**RE: GAAR Office Building - Renovations
1635 University Blvd. NE
Grading & Drainage Plan
Engineer's Stamp Date: 05/20/22
Hydrology File: H15D008**

Based upon the information provided in your submittal received 05/23/2022, the Grading & Drainage Plan **is not** approved for Building Permit. The following comments need to be addressed for approval of the above referenced project:

SHEET TITLE
GRADING and DRAINAGE PLAN

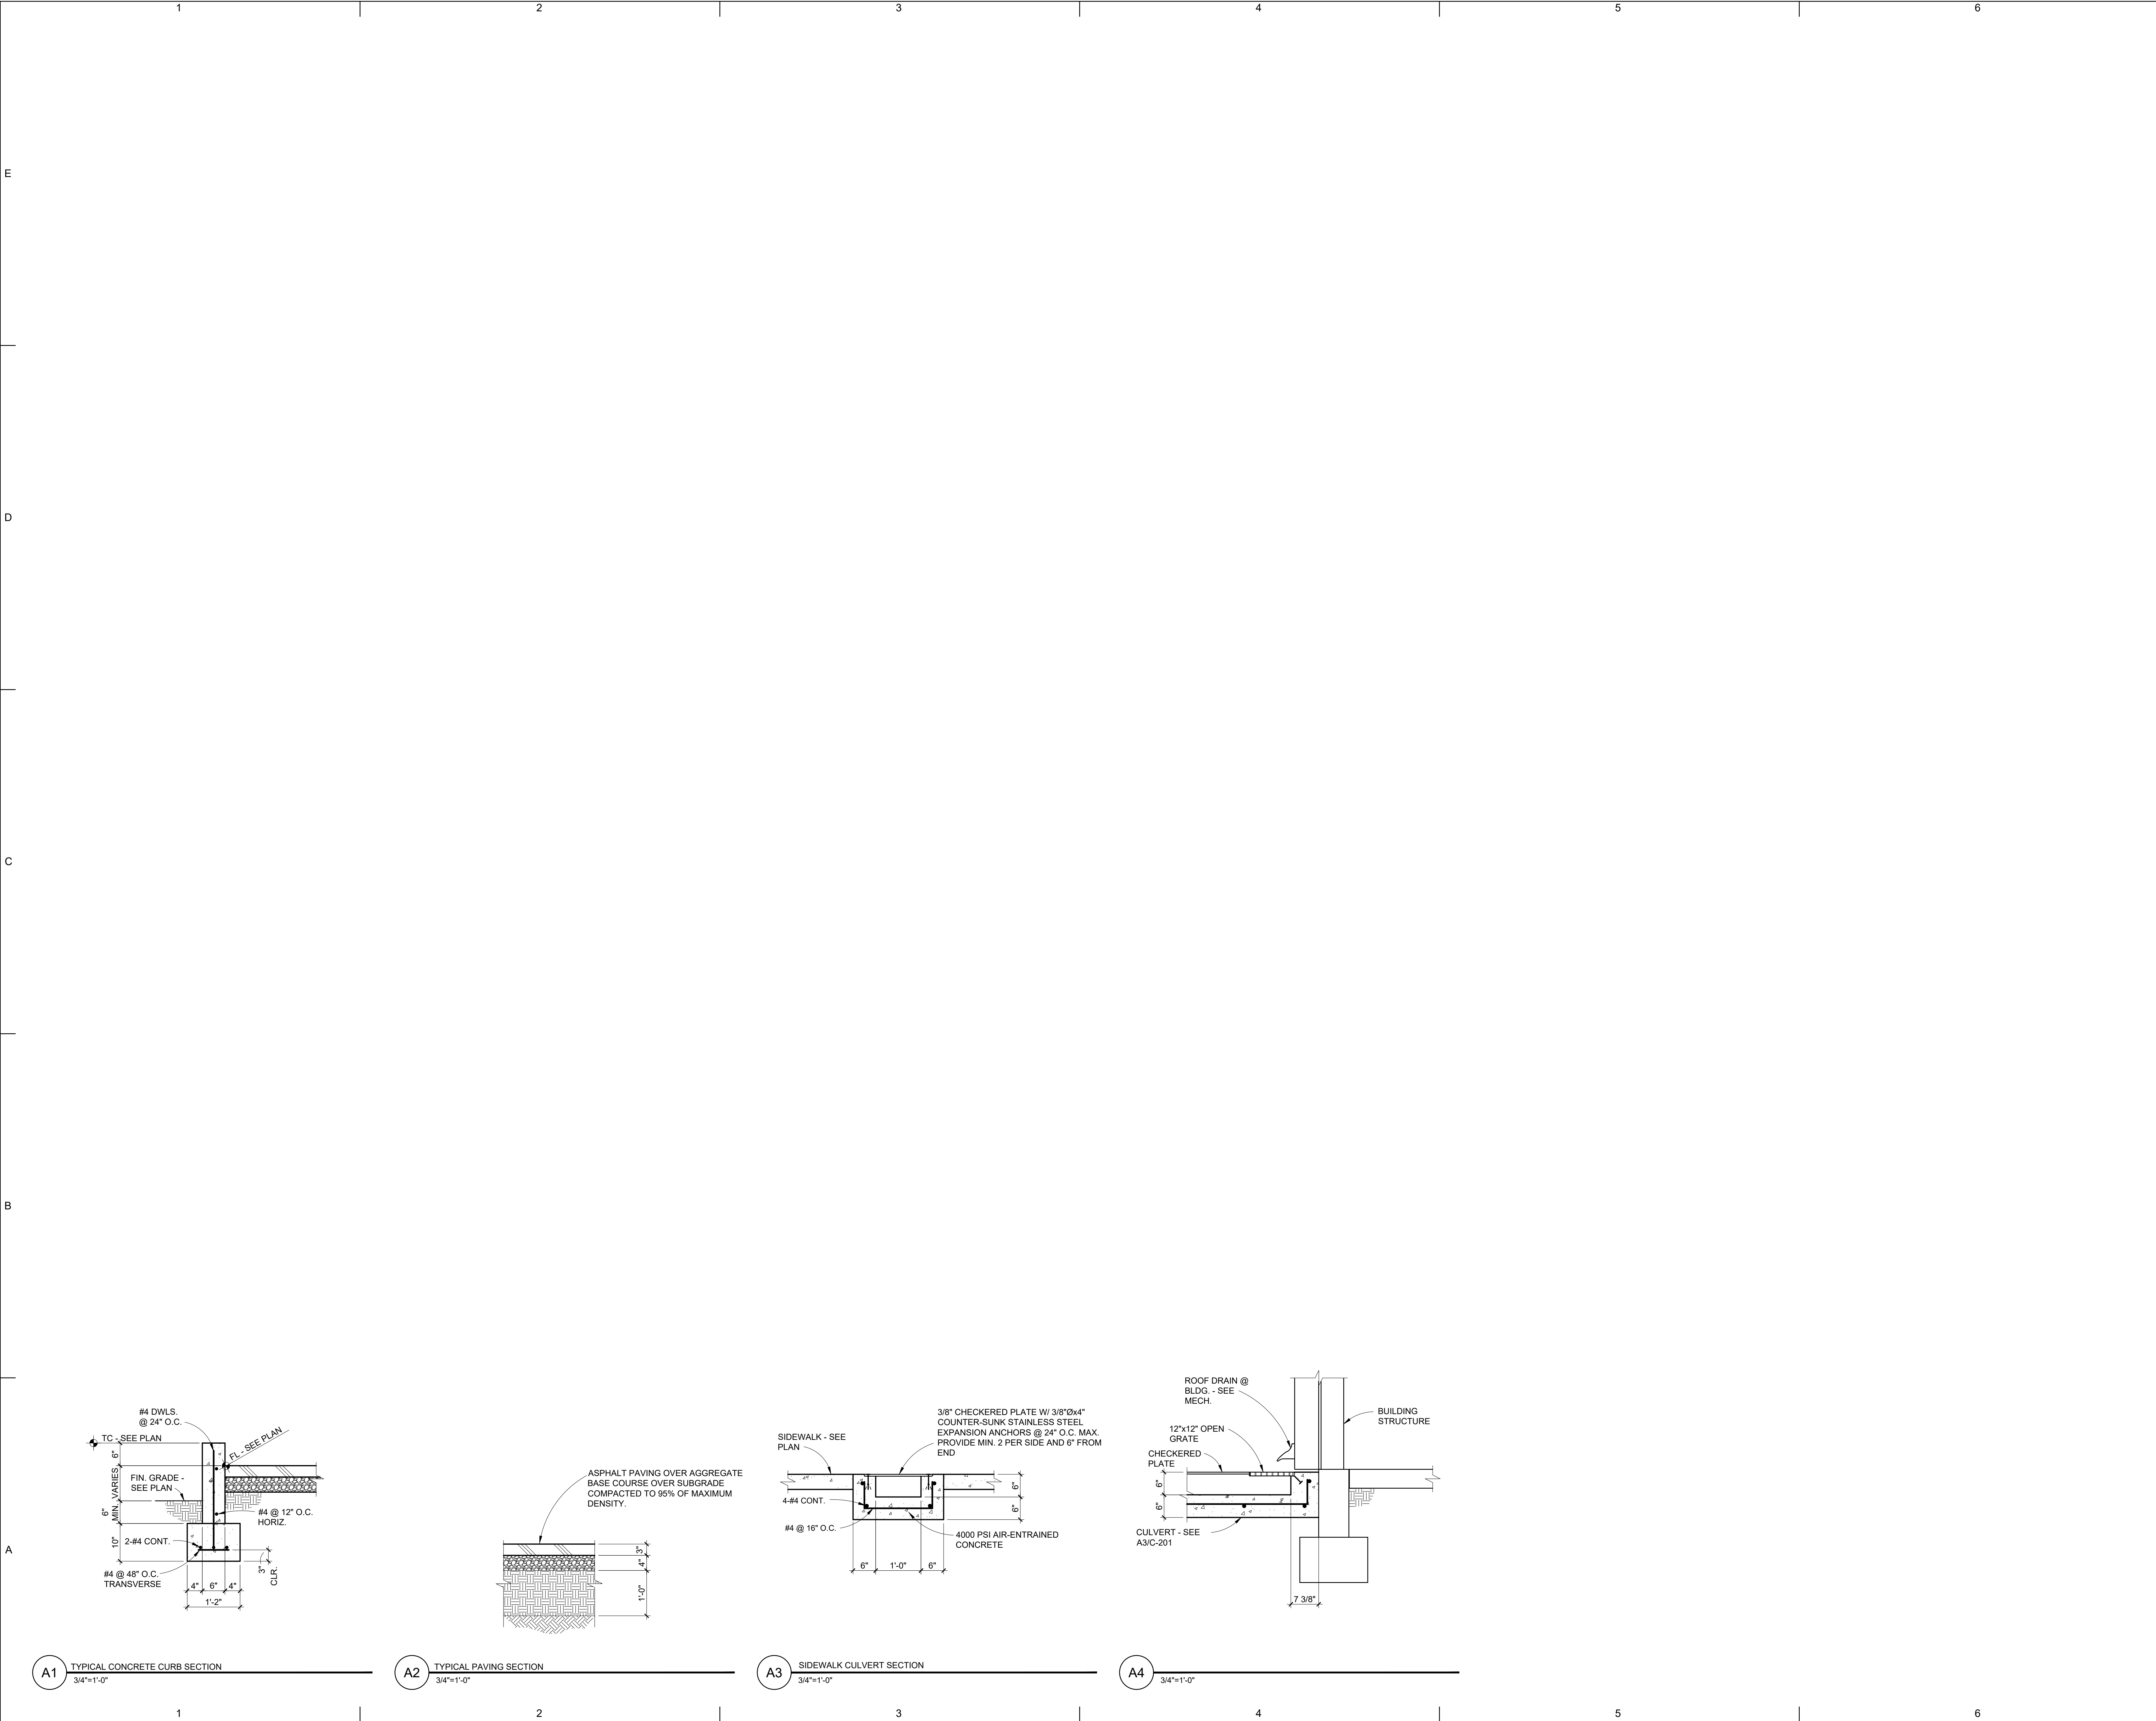
1. Since this project discharges into a New Mexico Department of Transportation's (NMDOT) drainage facility, approval must be obtained from NMDOT D3 Drainage. Please contact Tim Trujillo P.E (TimothyR.Trujillo@state.nm.us or 505-373-4987).
2. Please provide Stormwater Quality Volume (SWQV) calculations per the DPM Article 6-12 Stormwater Quality and Low-Impact Development. Since this is a redevelopment, to calculate the required SWQV, multiply the impervious area (the new proposed pavement, sidewalk, and building addition) in square feet by 0.26 inches then divide by 12.
3. If requesting a Waiver of Management Onsite, the following conditions of the new drainage ordinance (enacted 10/2/18) must be demonstrated on the plan (§ 14-5-2-6 (H)):

Show where stormwater quality can be effectively controlled through private offsite mitigation, or through an arrangement to utilize a cooperator's existing regional stormwater management infrastructure or facilities that are available to control stormwater quality.

And where one (or more) of the following is met:

- a. the lot is too small to accommodate management on site while also accommodating the full plan of development;
- b. the soil is not stable;
- c. the site use is inconsistent with the capture and reuse of stormwater;

- d. other physical conditions exist where compliance with on-site stormwater quality control requirement leaves insufficient area;
 - e. public or private off-site facilities provide an opportunity to effectively accomplish the mitigation requirements of this ordinance;
 - f. there is an opportunity to develop a project to replenish regional ground water supplies at an offsite location; or
 - g. a waiver to state water law or acquisition of water rights would be required in order to implement management on site.
4. If the site qualifies for a Waiver of Management Onsite for the Stormwater Quality Volume (SWQV), then please submit the form and please add a note which states, "The Owner has elected to pay the Payment in Lieu for the required Stormwater Quality Volume."
